City of Hamilton

PUBLIC WORKS COMMITTEE REVISED

Meeting #: 21-016
Date: November 1, 2021
Time: 1:30 p.m.
Location: Due to the COVID-19 and the Closure of City Hall (CC)

8.1.	Hamilton Water Leak Detection Program (PW21063) (City Wide)	82
8.2.	Update to Hamilton's Solid Waste Collection Design Guidelines for Developments (PW21061) (City Wide)	107

2 500 JAMES ST N - PROPOSED HAMMERHEAD IMPACTS
A0.02 1:200

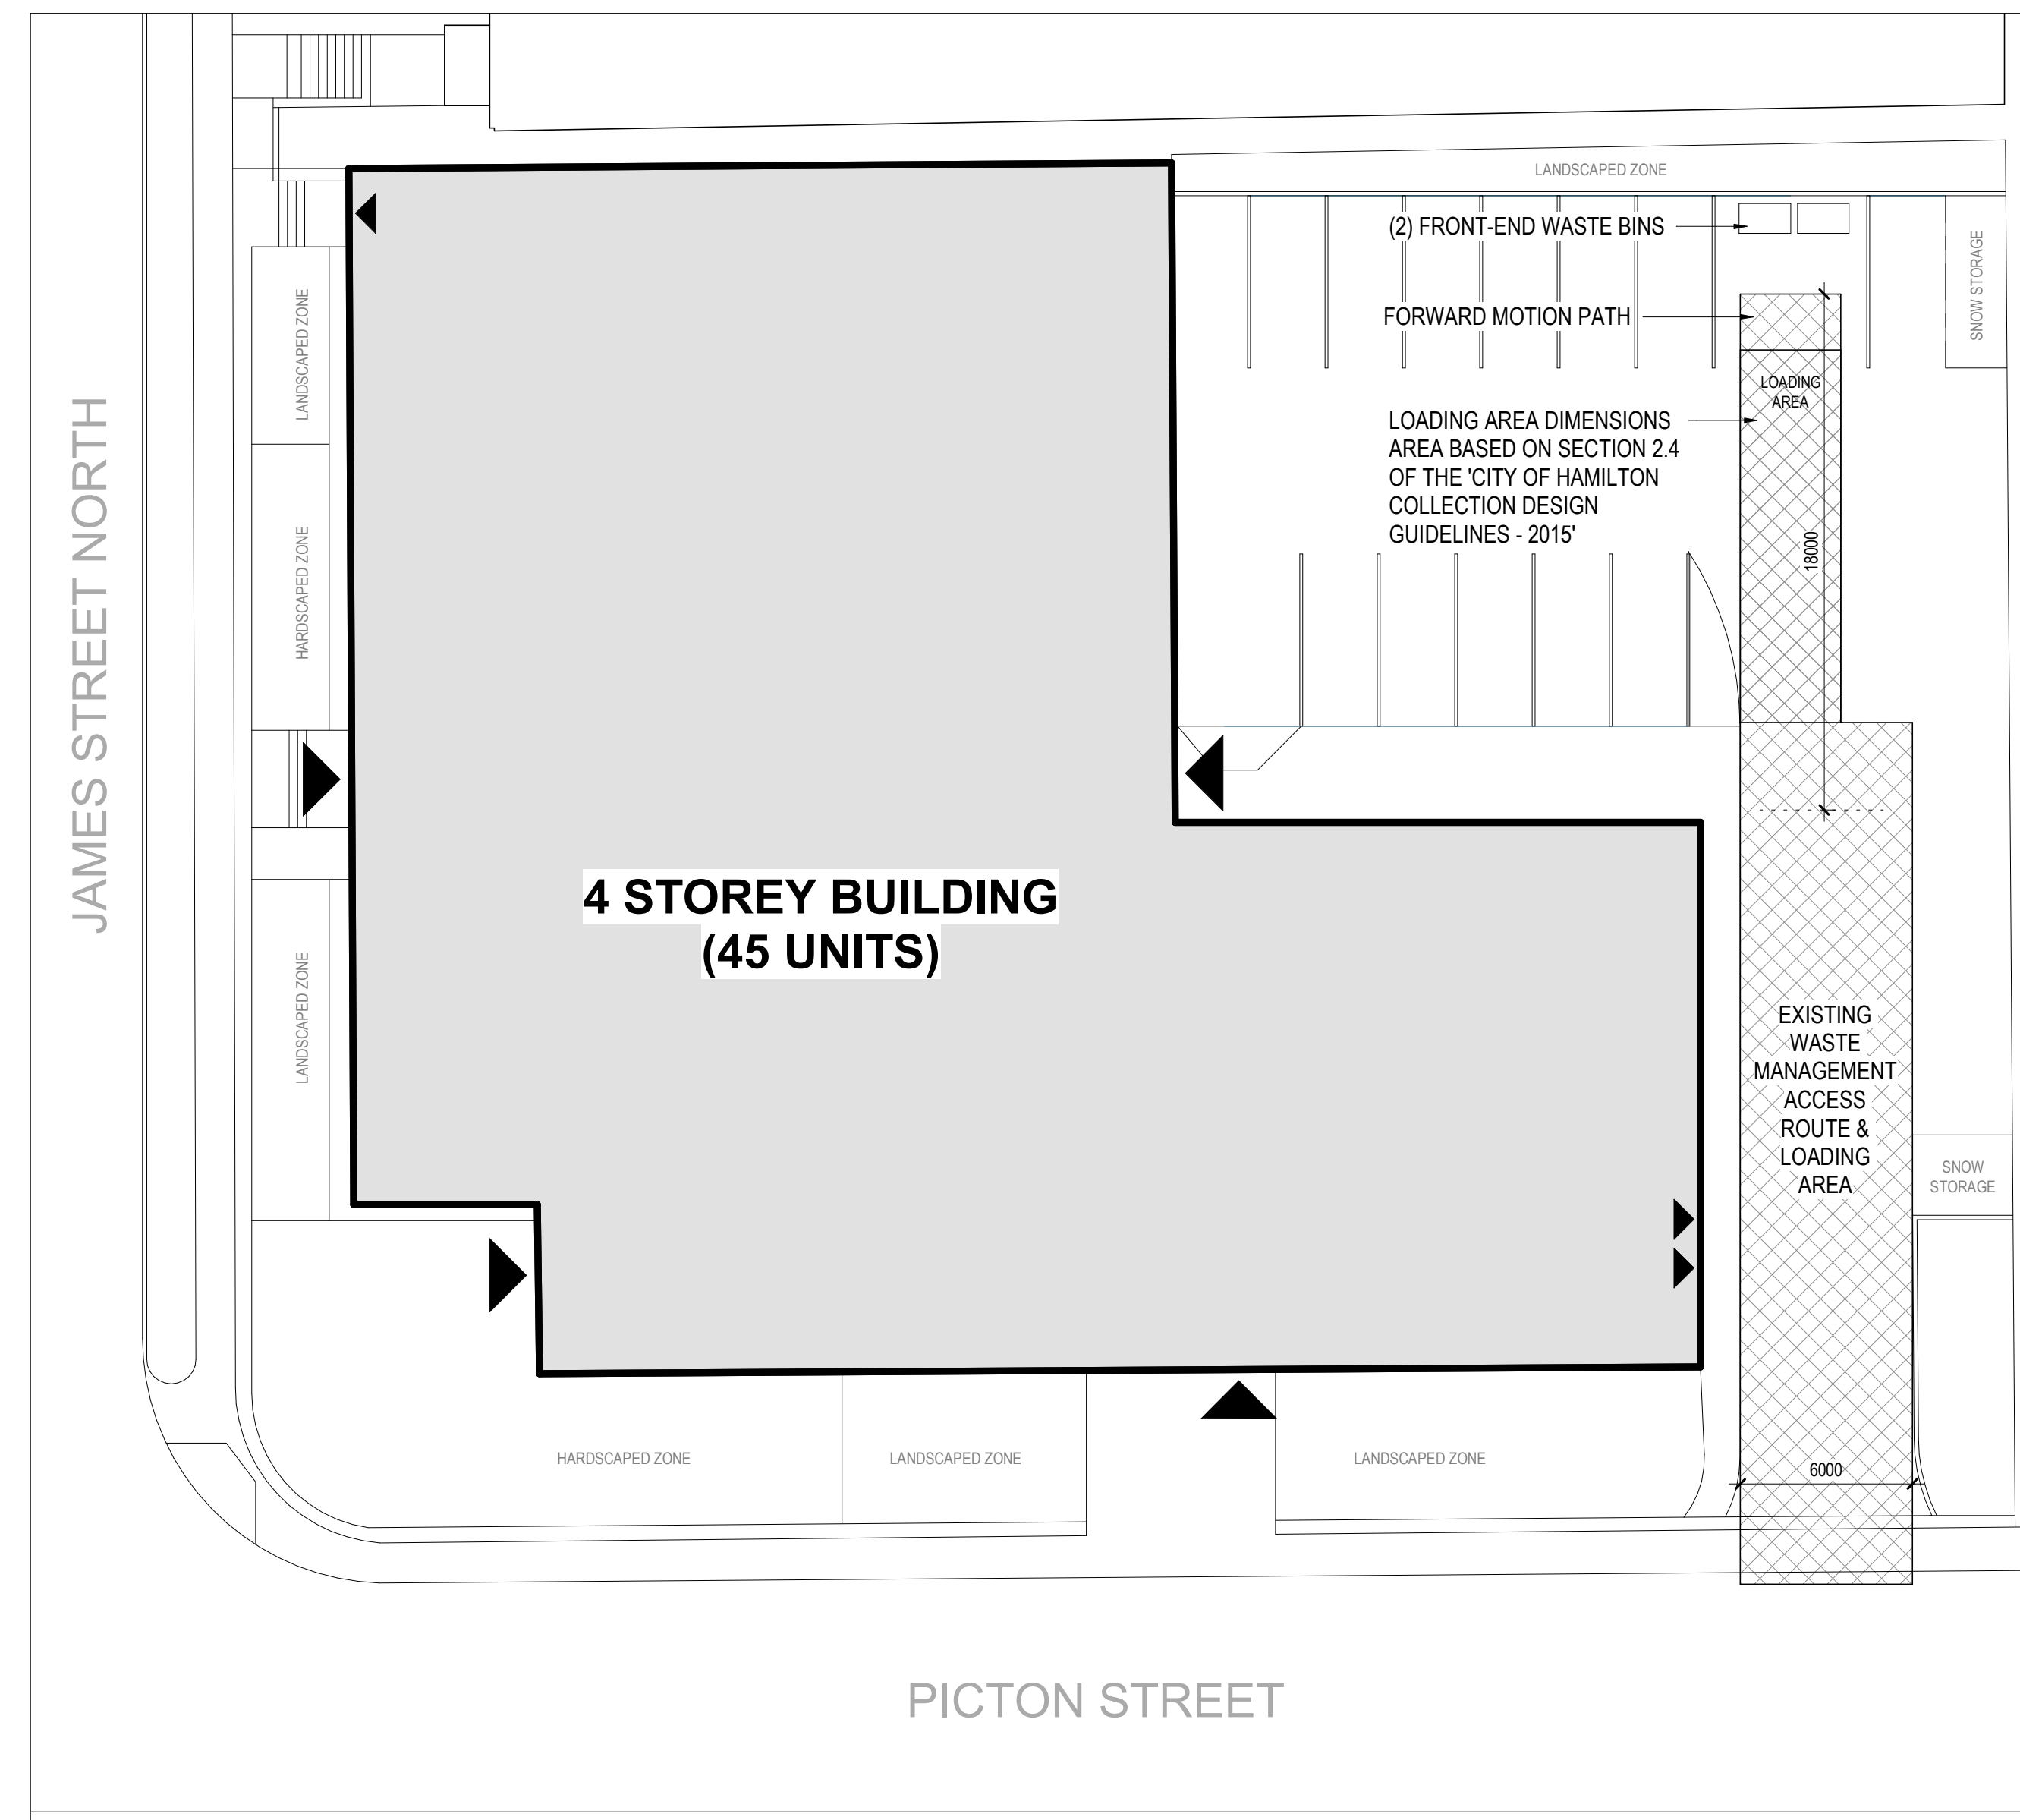
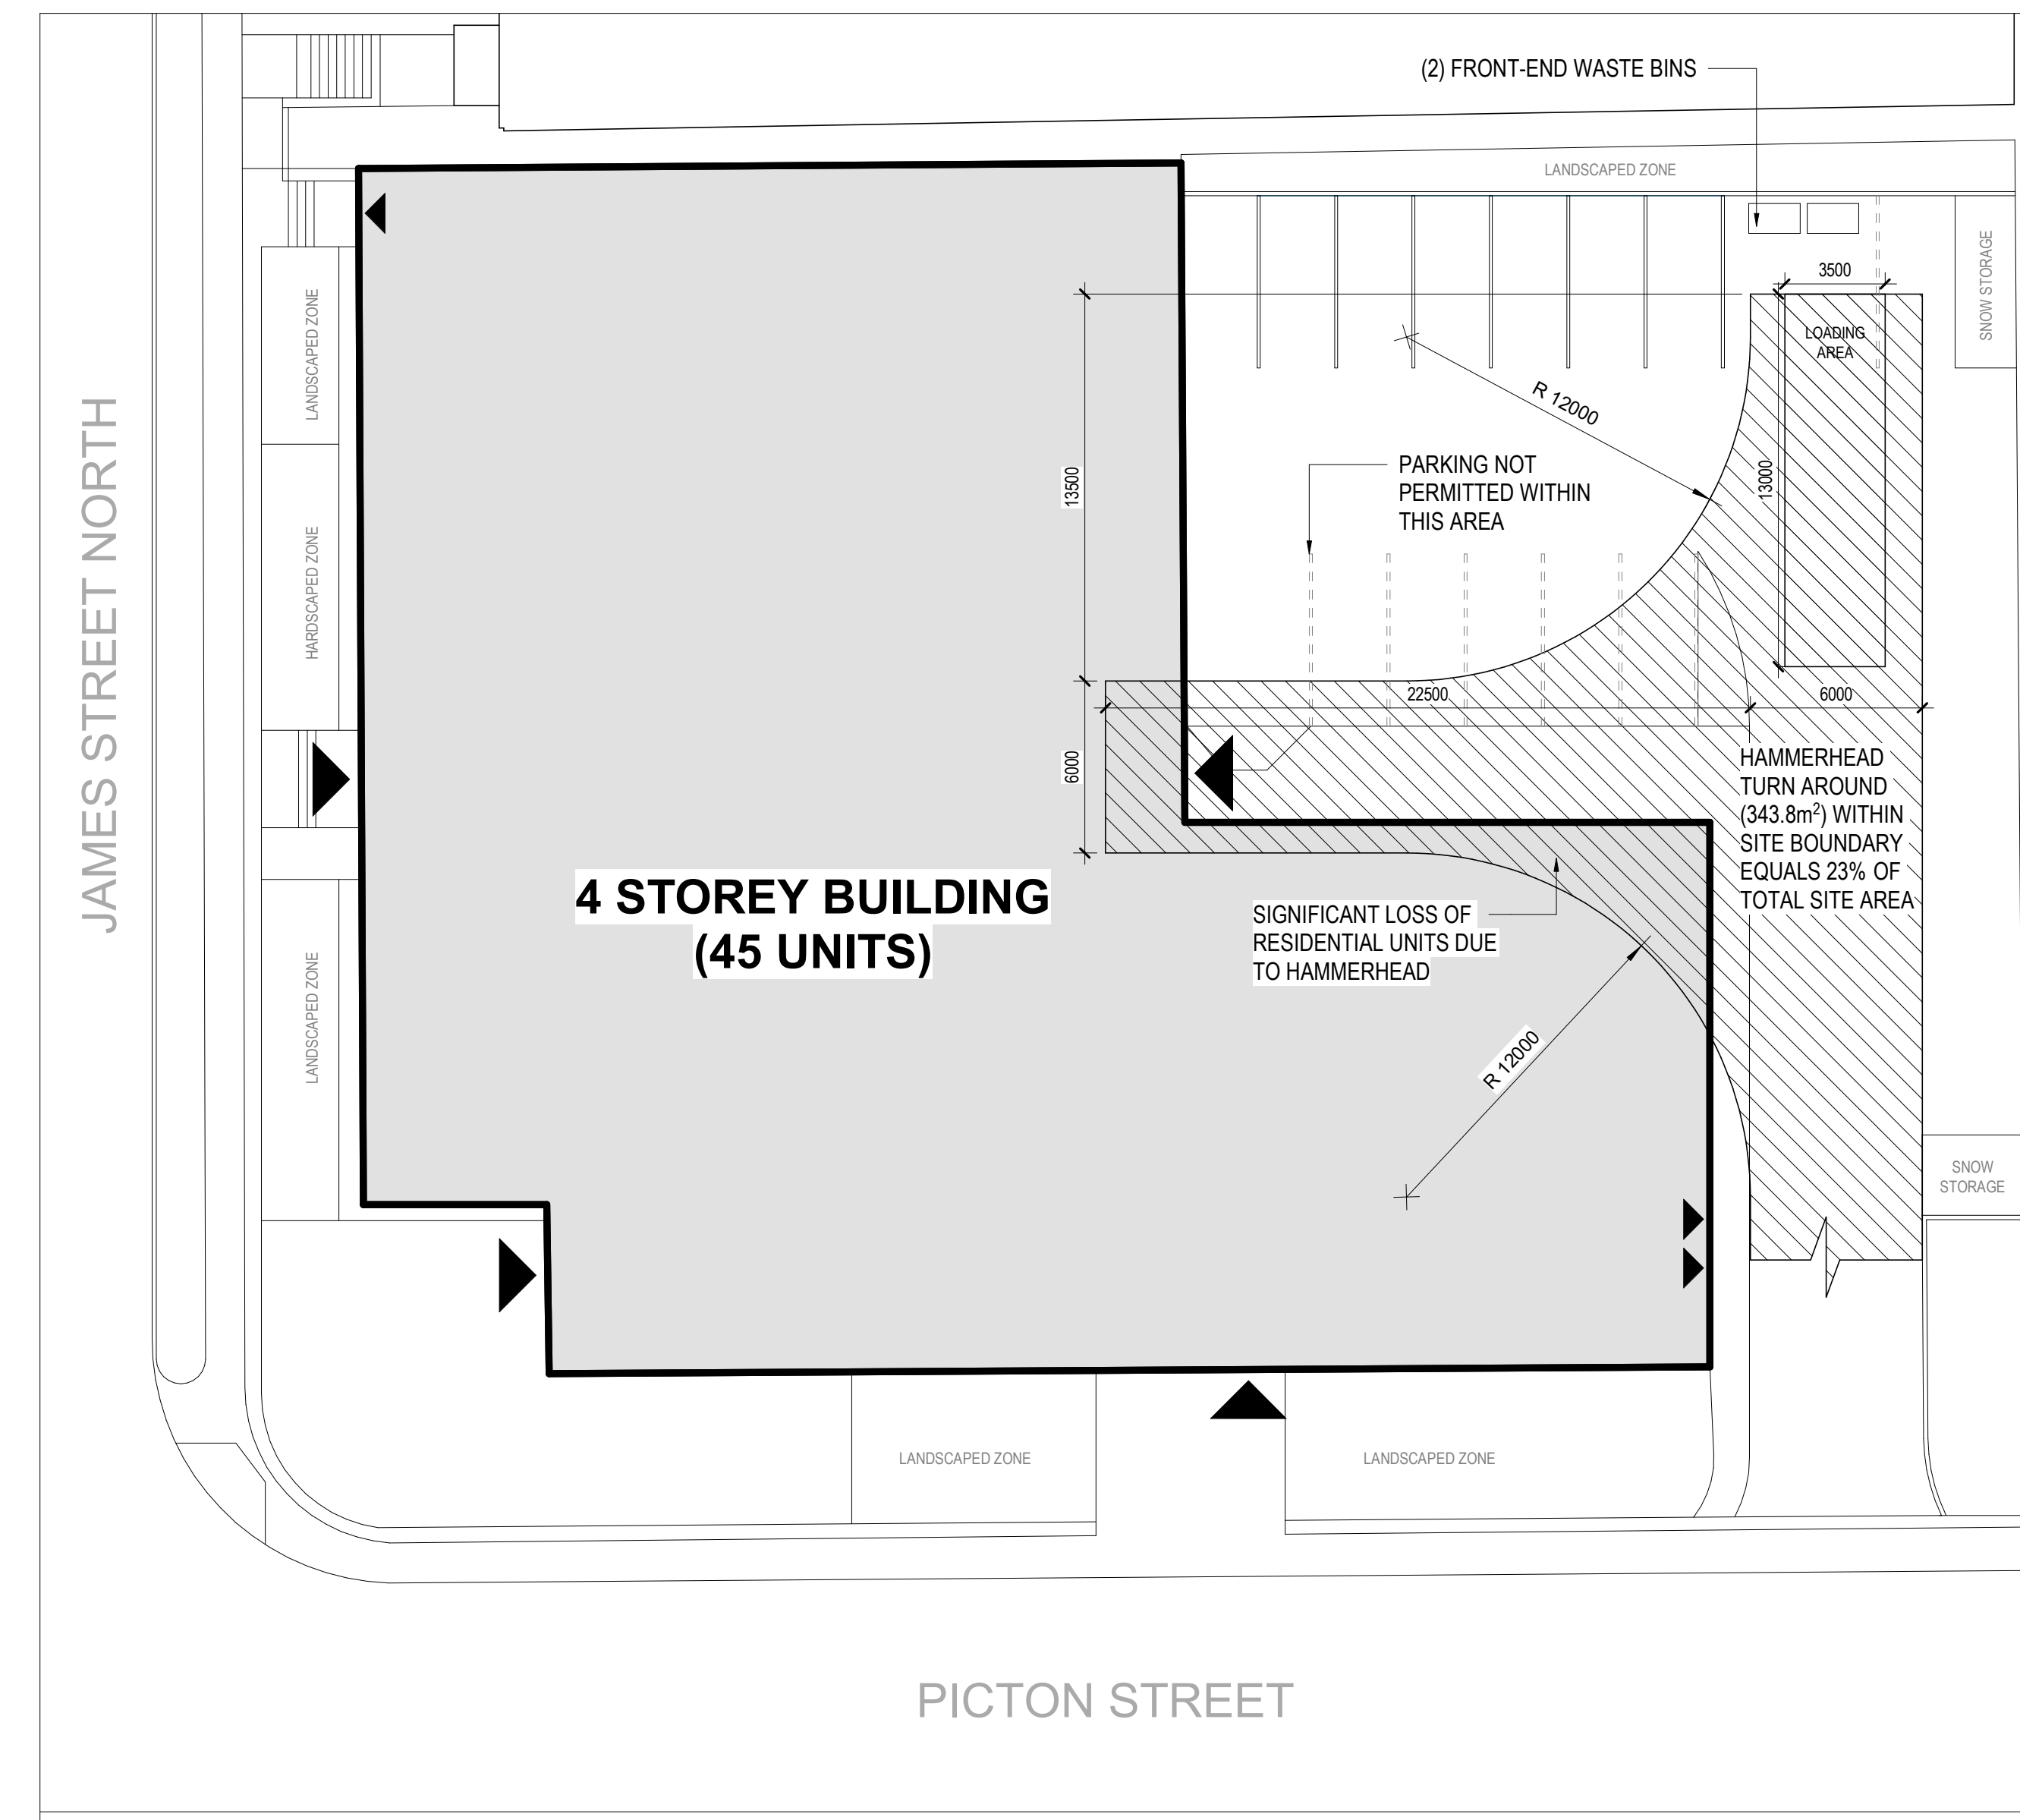
TOTAL LOSSES:

45 UNITS IS REDUCED TO 41 UNITS BASED ON BUILDING AREA CLEAR OF HAMMERHEAD

16 PARKING SPACES IS REDUCED TO 7

REDUCTION OF PARKING MEANS FURTHER REDUCTION OF UNITS (BASED ON SECTION 5.6 OF BY-LAW 05-200 ASSUMING UNITS AS >50m², AT 0.5 PER UNIT A FURTHER REDUCTION OF 14 UNITS OCCURS)
